**From:** David Romaine [dromaine@rasionline.net]  
**Sent:** Friday, August 07, 2009 1:03 PM  
**To:** Ullrich, Elizabeth  
**Cc:** 'Ryan Hinkle'; 'Sha'aban ElNaggar'; 'Christine Slachta'; 'Lyle Kinne'  
**Subject:** FMC building 22  
**Attachments:** Building 22.pdf

I apologize for the wording in Sec 2.2 of the FMC MARSSIM FSS report. The words "source material" was not a proper term of art to describe the use of building 22. The building was a temporary storage for low level radioactive material that was transferred to building 2 . No radiological work was conducted inside building 22.

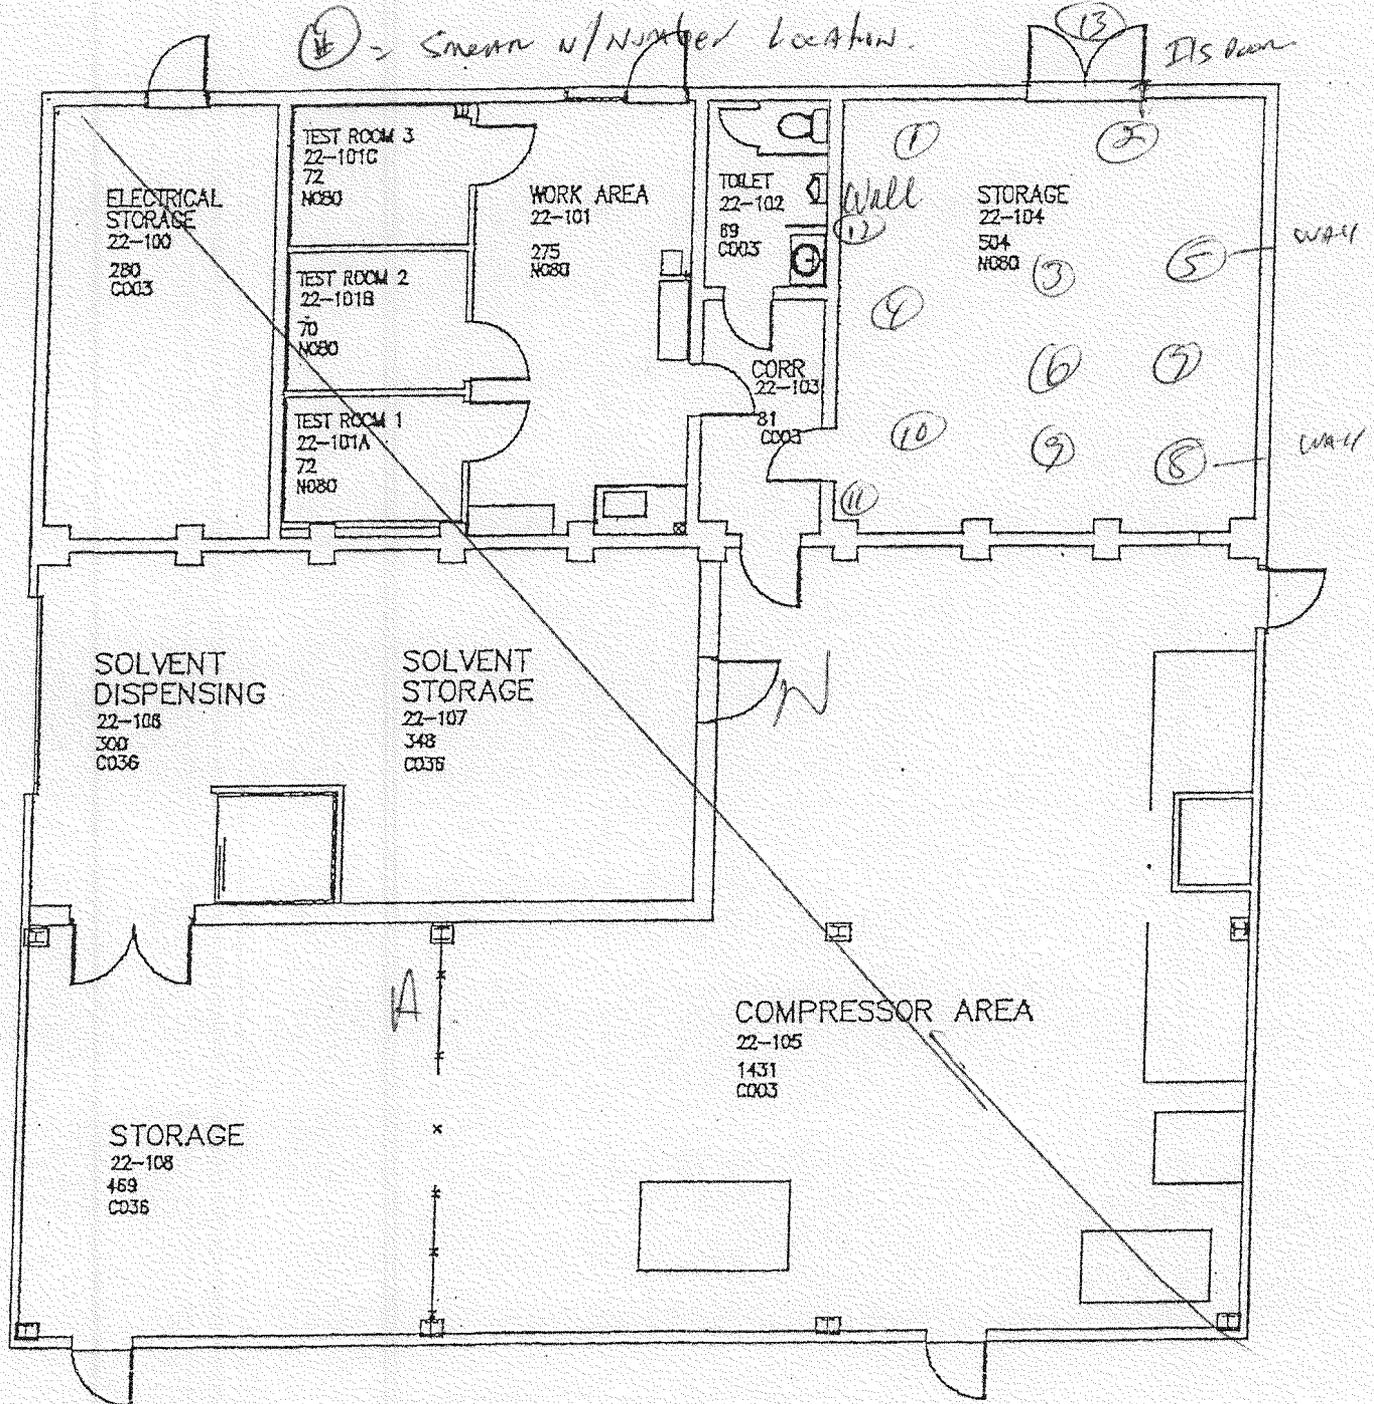
To continue with our clients request to provide the most conservative approach to releasing the Site, RASI conducted a survey of building 22 yesterday to confirm the absence of any contamination. The survey is attached. The smear results range from 0-6 dpm/100cm2.

All SCANS with Survey meter  
Indicates  $\leq$  Background  
Background = 40 cpm.
